# Minutes of the Chilton Parish Council Planning Meeting held on Wednesday 13th August 2025 at 8.00pm in the Village Hall

Amendments relating to application number P25/V0269/FUL for the 'Installation of perimeter fence, CCTV and two security kiosks' have been deposited with the District Council as Local Planning Authority. (Amended plans and documentation received 18 July 2025 and 30 July 2025).

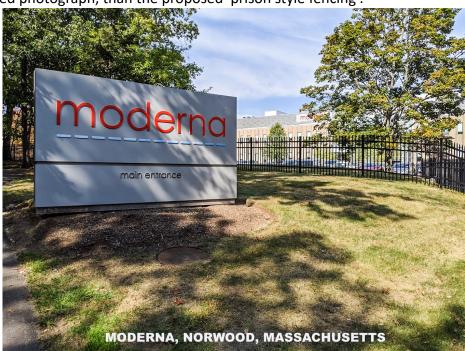
It is noted that the Moderna Head Office in Norwood, Massachusetts has a significantly less obtrusive fence demarking the surrounding public space - see attached photograph, than the proposed 'prison style fencing'.
